Transmission Expansion Advisory Committee – AEP Supplemental Projects

March 08, 2022

AEP Transmission Zone Supplement Project S2270 Scope Change

S2270.1-.7 (2020 AEP local plan)

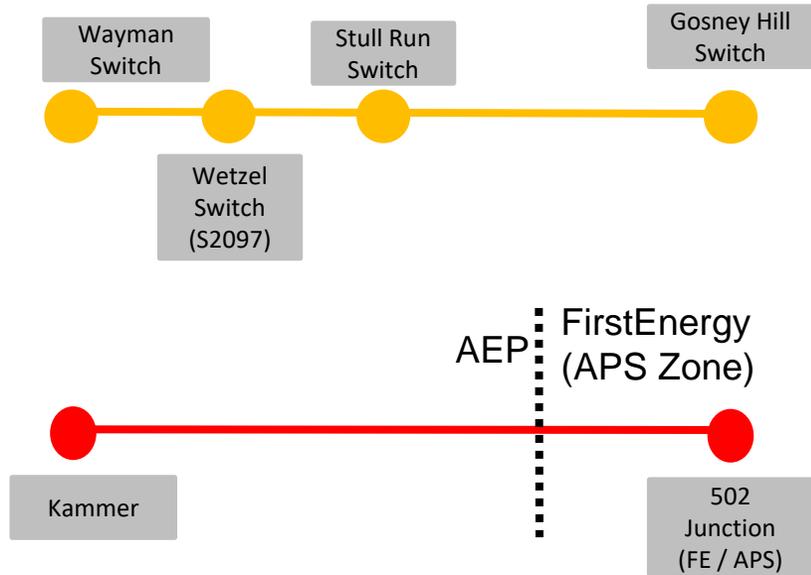
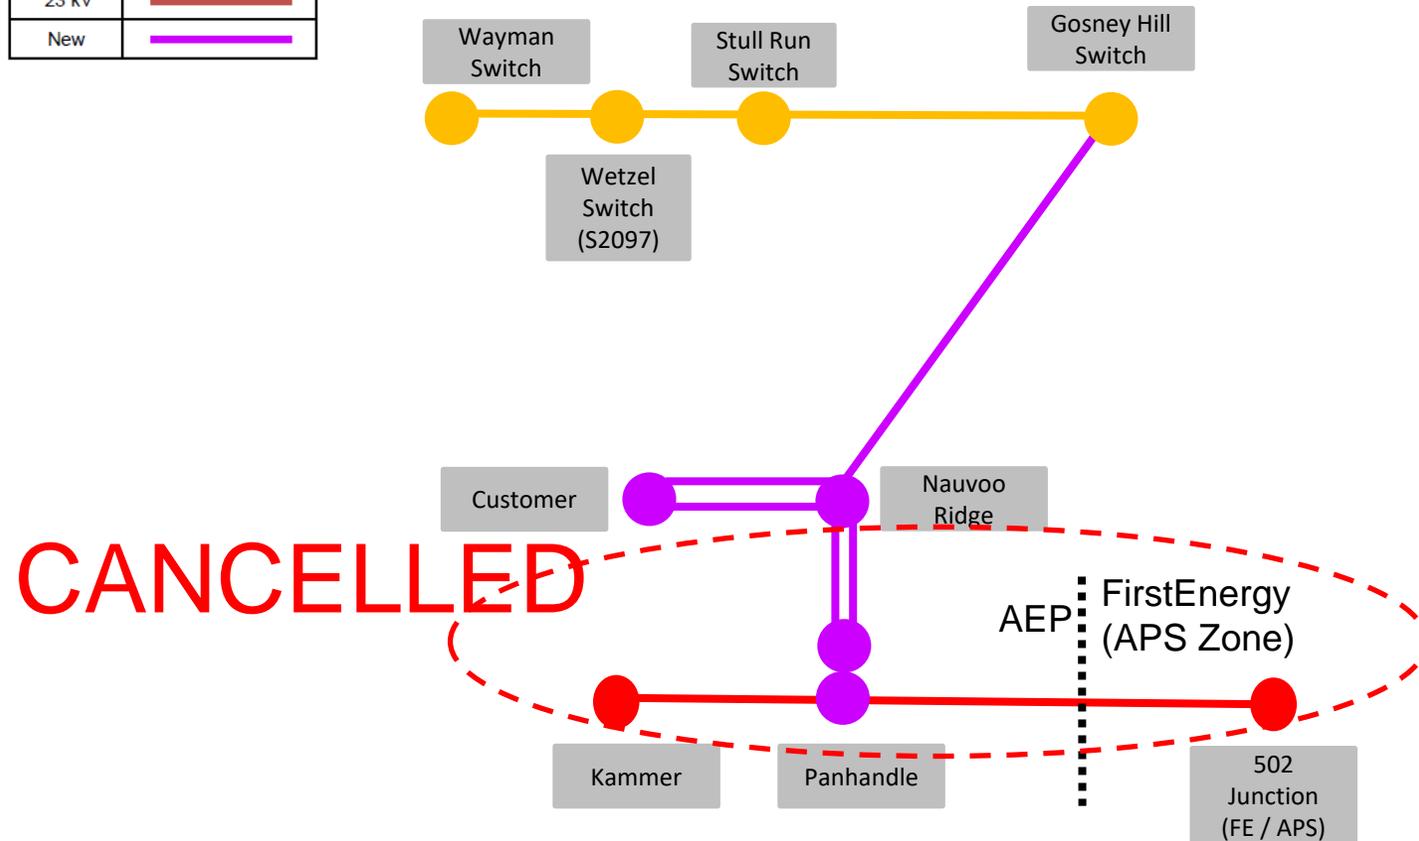
After further site exploration and preliminary engineering for the Panhandle 500-138kV station, the cost estimates increased significantly, due to the large amount of civil grading scope required, in this very hilly area of West Virginia. The total station cost estimate rose to \$105.5 million for a traditional, open-air design. AEP also evaluated a hybrid GIS station design, which used GIS for the 500kV portion of the station; this cost estimate was \$95.0 million. In addition, the cost estimate to modify the 500kV transmission line increased to over \$4 million. Overall, Panhandle was no longer a cost-effective system upgrade, so alternatives were studied, which are described in the following slides.

Cancel the following Supplemental upgrades:

- S2270.1 – Panhandle 500-138kV station
- S2270.6 – 1.5 mile double-circuit 138kV line from Panhandle to Nauvoov Ridge
- S2270.7 – Modify the Kammer-502 Junction 500kV line to connect to Panhandle station
- On S2270.3 (Gosney Hill), this portion can be cancelled, as it is no longer overloaded: Replace the 795 kcmil AAC risers and strain bus with 2000 kcmil AAC risers.

Proposed (After Scope Change):

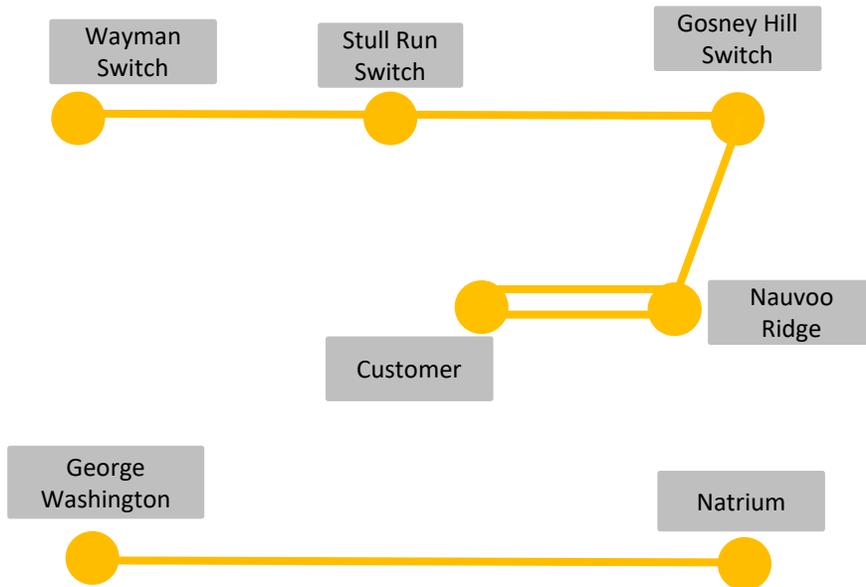
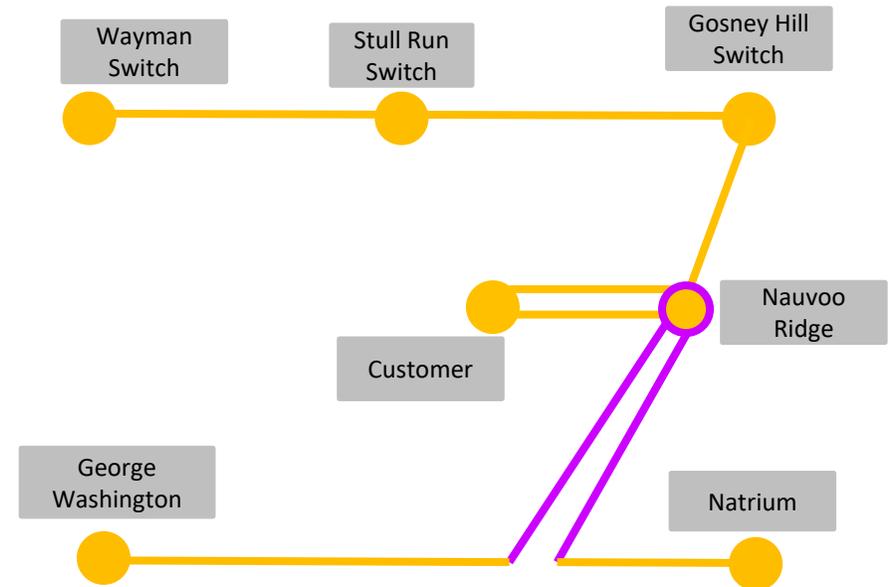
Construct a new 138kV switching station (Nauvoo Ridge) with 8- 138kV breakers in a breaker-and-a-half design. The station will have 1 circuit to Gosney Hill, 2 circuits to the customer's facility, ~~2 circuits to Panhandle~~ 1 circuit to George Washington, 1 circuit to Natrium, and a 23 MVAR 138kV cap bank. **Estimated Cost: \$16.4 M-\$15.5 M (s2270.2)**

At Gosney Hill, install a new 138kV breaker toward Nauvoo Ridge. Update station protection. ~~Replace the 795 kcmil AAC risers and strain bus with 2000 kcmil AAC risers.~~ **Estimated Cost: \$1.3 M-\$1.0 M (s2270.3)**

~~Cut into the George Washington-Natrium 138kV circuit and extend an 8.6-mile double-circuit 138kV loop east to Nauvoe Ridge. (S2270.8) \$23.13 M~~

~~Modify the George Washington-Natrium 138kV line, which is part of a double-circuit lattice tower line. (S2270.9) \$0.65 M~~

New Total Estimated Cost: \$59.78 million *(compared to a total of approximately \$137.9 M, if the Panhandle 500-138kV option had proceeded)*

New Projected In-Service Date: 12/1/2023
